Application for Works Approval

Works Approval Number	W6598/2021/1
Applicant	CXTGD Investment Pty Ltd
ACN	641 676 628
File number	DER2021/000020
Premises	Erim Downs Cattle Feedlot 19094 Brand Hwy WARRADARGE WA 6518 Legal description – Lot 10804 on Plan 210800 As defined by the coordinates in Schedule 2 of the works approval
Date of report	02/11/2022
Decision	Works approval granted

Figure 1: Existing feedlot design and layout

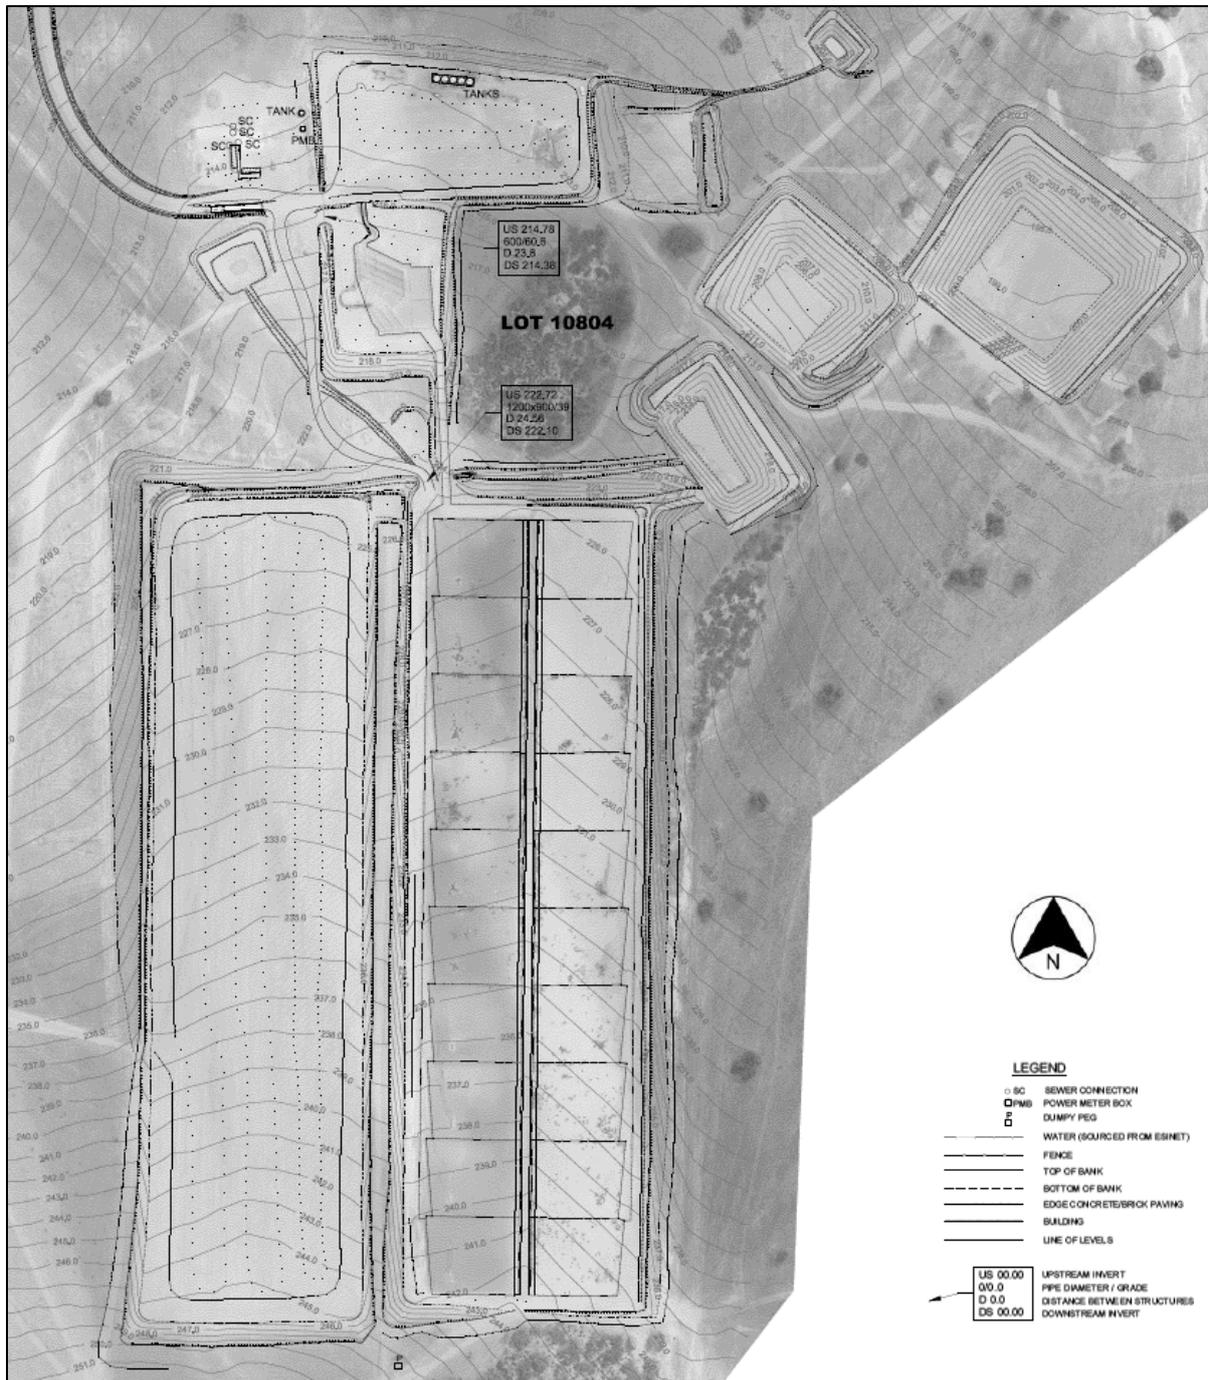
An audit conducted shortly after operations commenced in 2018 found the as-constructed drains to be only simple, basic excavations into the in-situ gravelly, silty clay soils. Compaction and layering was not evident, nor had any rubble, geomembranes or high-energy drain structures been installed. Some earthen material had been placed at selected points in some drains, however no other flow modification devices had been installed.

An audit conducted shortly after operations commenced in 2018 found that it was still unclear to what dimensions and standards the sedimentation basin had been constructed to, or that it had sufficient storage capacity to ensure it did not overtop at an unreasonable frequency. It was also identified the connecting pipe between the basin and the primary effluent holding pond had not been installed, and the spillway to the holding pond had only been partially constructed with no rubble or geomembrane installed.

According to an audit conducted shortly after operations commenced in 2018, the primary pond has been constructed with a design storage capacity of 35,000 m³ and the secondary pond 60,000 m³, providing a total storage capacity of 95,000 m³. The original May 2017 application indicated this was based on capturing runoff during a 1:20 year ARI event from a total pen area of 16.9 ha, however no runoff calculations were provided to demonstrate how this was determined or whether this would be sufficient to ensure the ponds did not overtop at an unreasonable frequency.

A review by the applicant identified several key design flaws with the controlled drainage infrastructure, such as:

- the absence of controls to prevent the ingress of clean surface water runoff into CDA1 & 2;
- the side drains are not adequately sized, or designed to manage high velocity flows;
- the sedimentation ponds are undersized;
- CDA 1 does not have a holding pond;

- CDA 2 two holding ponds only have adequate capacity for 1 in 10-year annual rainfall events;
- Ponds are not adequately protected with weirs and spillways in the event of overtopping or spill events;
- Sedimentation systems are not designed to provide for low flow velocities;
- Sedimentation systems and holding ponds do not have spillways to handle extreme rainfall events.
